**Brookhaven National Laboratory**  
**Plant Engineering - E&CS Division**  
**Engineering Change Notice Form**

**PROJECT:** CCWF II

**ECN Title:** Parapet Detail

**ECN No.** 26

504S PARAPET DETAIL  
 A-302 N.T.S.

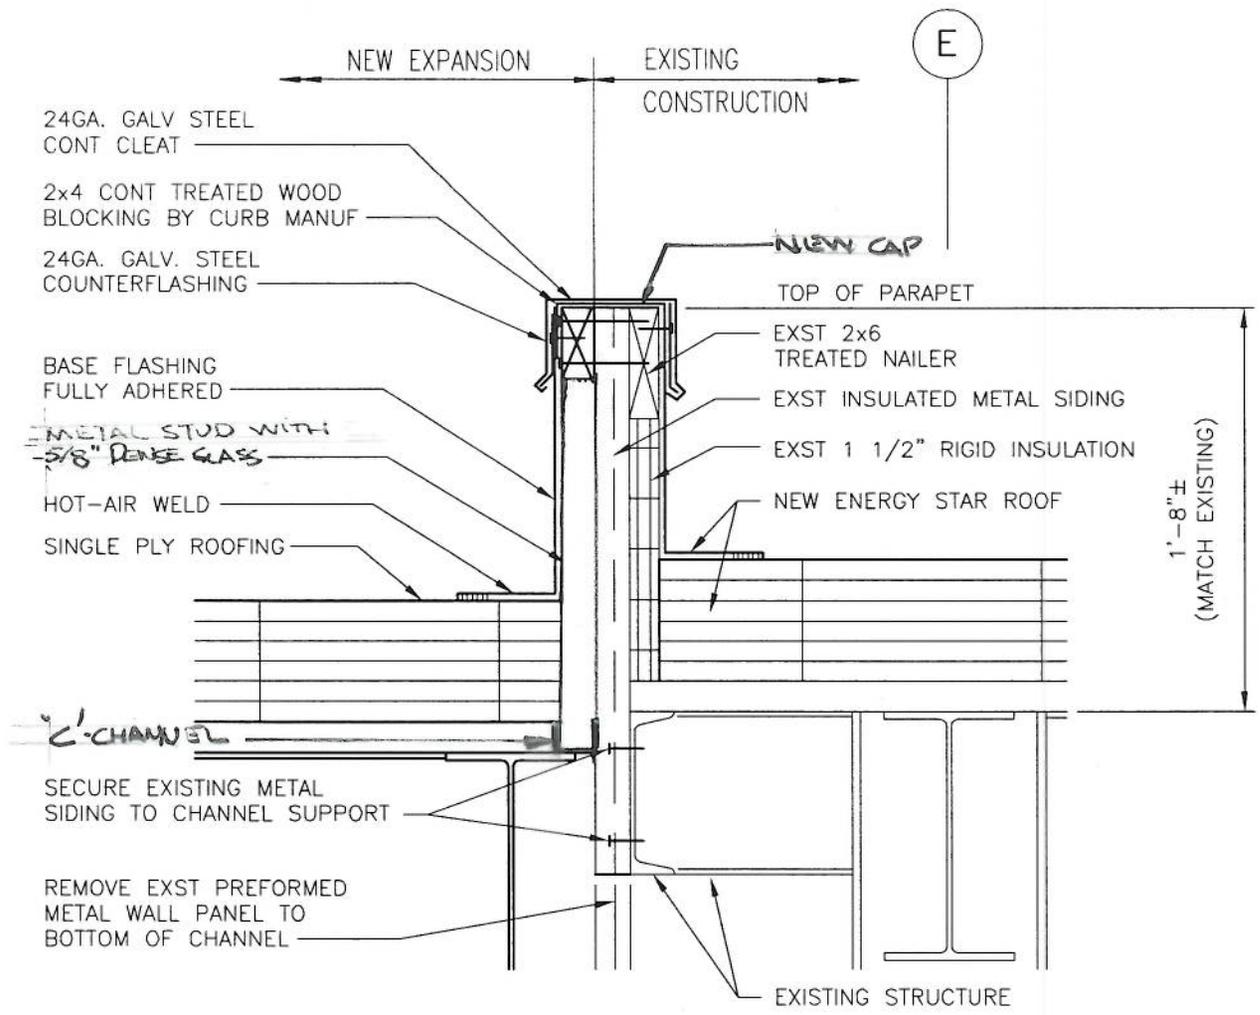
Requested Change (Attach sketch if applicable): Interface parapet between new and existing roofing at all levels. Provide new wider continuous 24 GA. cleat, treated wood blocking, counter flashing, base flashing, metal studs, DensGlass and curb insulation as per attached sketch.

Resolution: See the attached sketch.
